K144XV REFERENCE OSCILLATOR PHASE LOCK OPTION MANUAL ERRATA

Rev. A2-2, December 5, 2015
E740155E

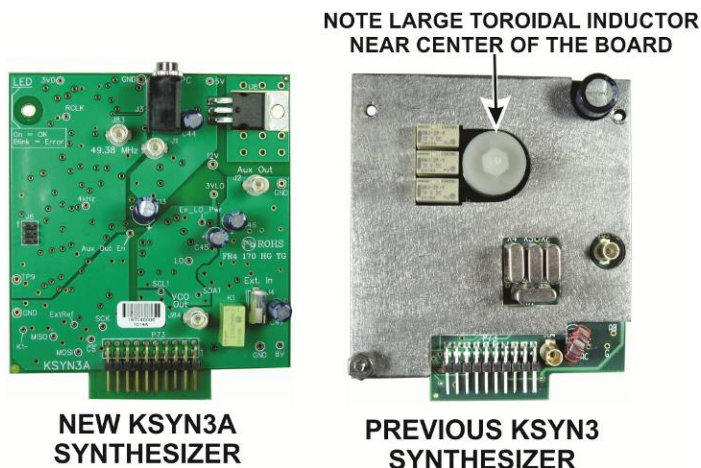
A new synthesizer pc board is now being shipped for your K3. The following changes are required if your K3 has the newer KSYN3A synthesizer board instead of the original KSYN3 board. The two boards are shown below:

Page 8: If your K3 has the new KSYN3A synthesizer, only one TMP coaxial cable is used as shown below. Do not connect a cable to the KREF3 board as shown in Figure 4 in the manual.
